Service Bulletin SB 2X-34-21

Models SR20 and SR22

ATA 34-10: Flight Environmental Data/Pitot-static Systems Alternate Static Valve Relocation

To provide for improved accessibility to the alternate static valve, this Service Bulletin provides for the relocation of the alternate static source valve.

Figure 01 - Alternate Static Valve Relocation

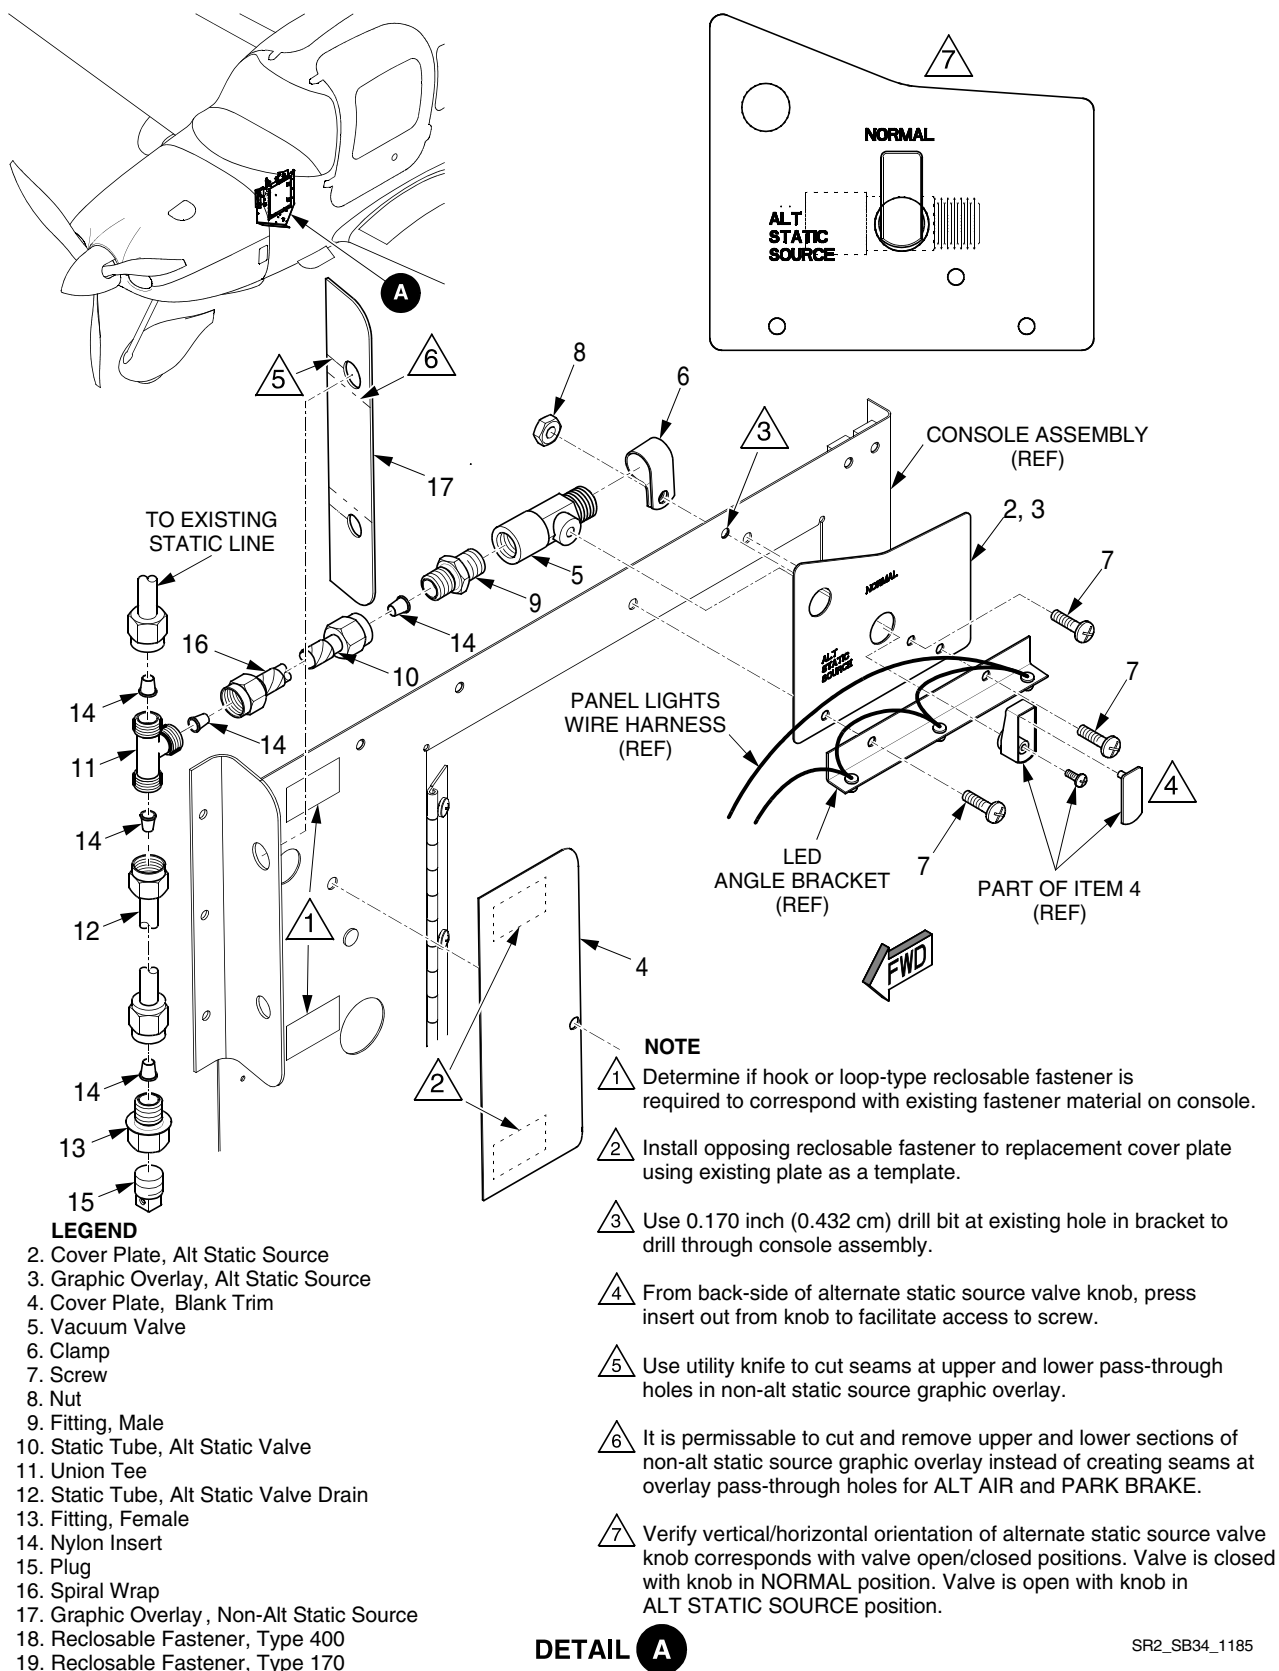
3. Use utility knife to cut graphic overlay (item 3) at pass-through holes in cover plate. Trim excess graphic overlay as required.
- N. Modify installation area. (See Figure 01)

1. Remove both screws securing LED angle bracket to console.
 2. Position alt static source cover plate (item 2) between console and LED angle bracket at installation area.

3. Install screws securing LED angle bracket and alt static source cover plate to console.
 4. Locate hole in alt static source cover plate positioned over surface of console assembly.

5. Use 0.170 inch (0.432 cm) drill bit at existing hole in cover plate to drill through console assembly.
 6. Deburr drilled hole and solvent clean with isopropyl alcohol. (Refer to AMM 20-30)

7. Apply alodine to drilled hole to prevent corrosion.
- O. Install alternate static source valve. (See Figure 01)
1. At inboard side of console, position clamp (item 6) to console at drilled hole location.

2. Loosely install screw (item 7) and nut (item 8) securing clamp to cover plate and console.
 3. Install male tube connector (item 9) to alternate static source valve (item 5).

5. Position replacement alternate static source valve to clamp with knob coupling oriented to pass-through hole in static source valve bracket.
 6. Position clamp over end of alternate static source valve. Tighten screw and nut securing clamp to static source valve bracket and console.

- P. Install and route alternate static source lines. (See Figure 01)
1. Remove connector from one of the side fittings of the union tee (item 11).
 2. Slide backside of connector over static line (item 12).

Figure 02 - Circuit Breaker Panel Modification

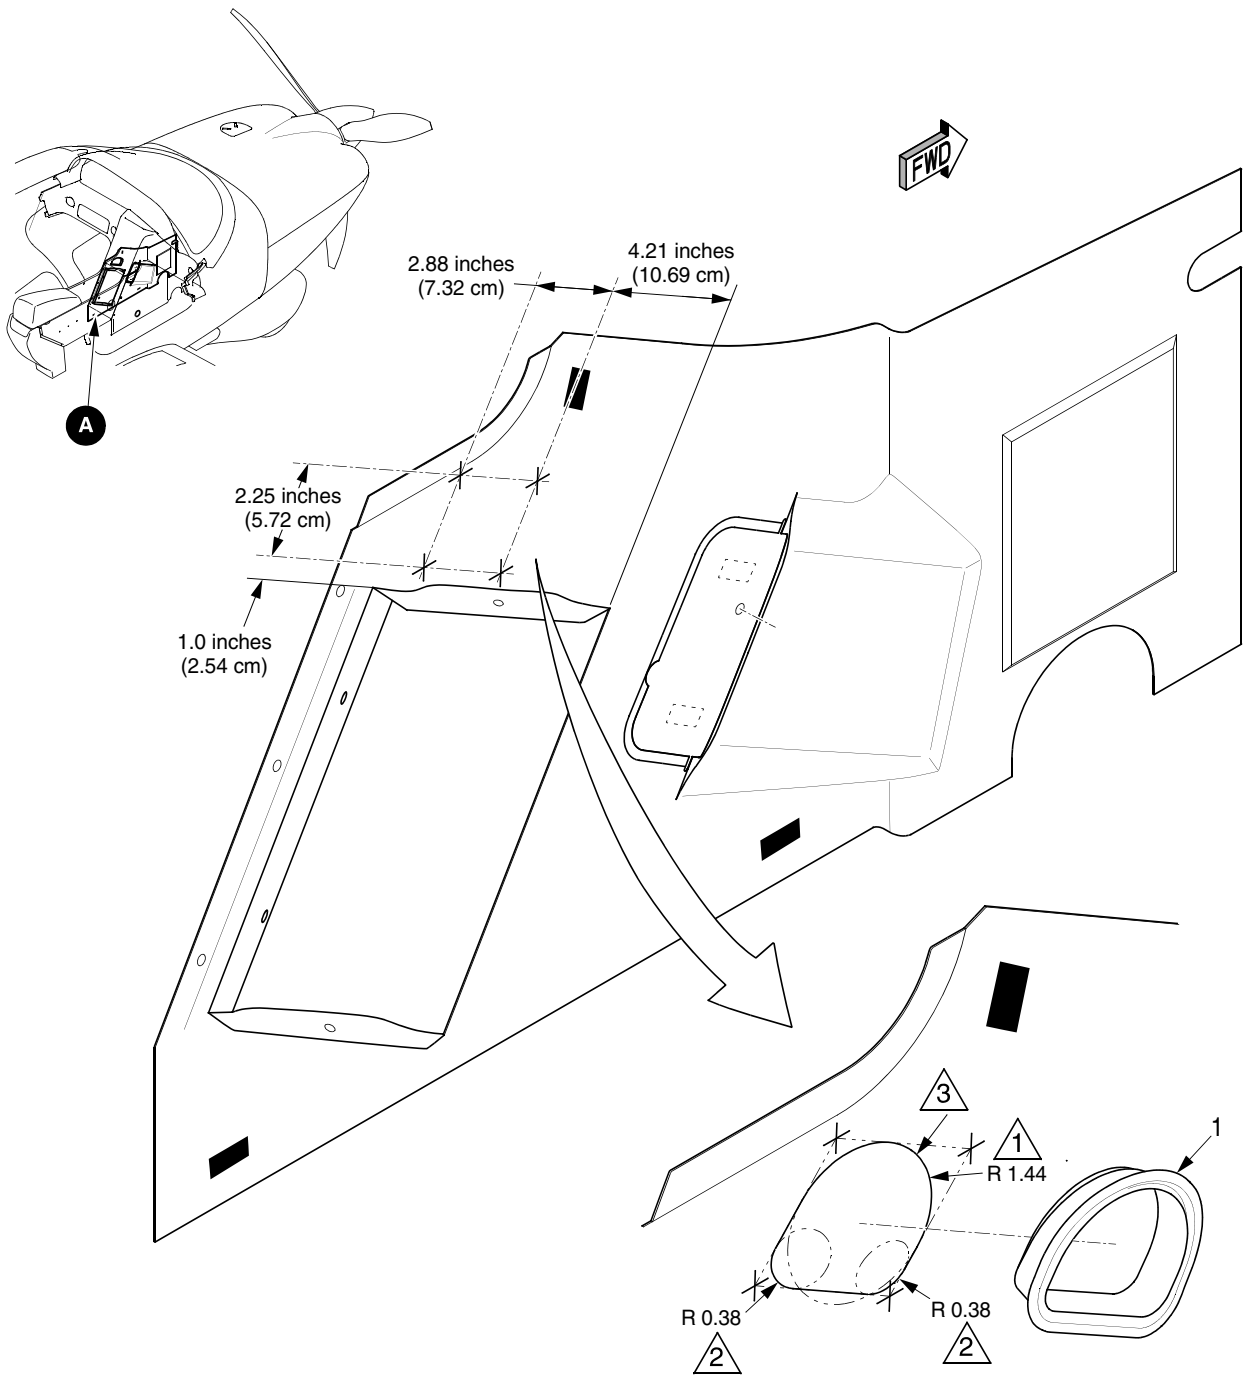
- Q. Modify circuit breaker trim. (See Figure 02)
1. At inboard circuit breaker trim, measure 4.21 inches (10.69 cm) aft parallel to upper edge of circuit breaker panel cut-out and 1.0 inch (2.54 cm) up perpendicular to upper edge of circuit breaker panel cut-out, then mark.

2. From previous mark, measure 2.88 inches (7.32 cm) aft parallel to upper edge of circuit breaker panel cut-out, then mark.
 3. From previous mark, measure 2.25 inches (5.72 cm) up perpendicular to upper edge of circuit breaker panel cut-out, then mark.

4. From previous mark, measure 2.88 inches (7.32 cm) forward parallel to upper edge of circuit breaker panel cut-out, then mark.
 5. Using straight-edge, draw rectangle connecting previous marks.

6. Center compass 1.44 inches (3.66 cm) from side and upper edges of rectangle, then mark arc intersecting upper edges of rectangle.
 7. Center compass 0.38 inch (0.97 cm) from lower corner edges of rectangle, then mark arc intersecting lower edges of rectangle. Repeat on opposite corner.

8. Using rotary tool with carbide cutting disc, cut rounded D-shape defined by previous marks.
 9. Deburr cut-out hole and solvent clean with isopropyl alcohol. (Refer to AMM 20-30)

- 1 Center compass 1.44 inches (3.66 cm) from side and upper edges of rectangle, then mark arc intersecting upper edges of rectangle.
- 2 Center compass 0.38 inch (0.97 cm) from lower corner edges of rectangle, then mark arc intersecting lower edges of rectangle. Repeat on opposite corner.
- 3 Apply sufficient quantity of adhesive to installation area around edges of cut-out to completely fill gap between faying surfaces.
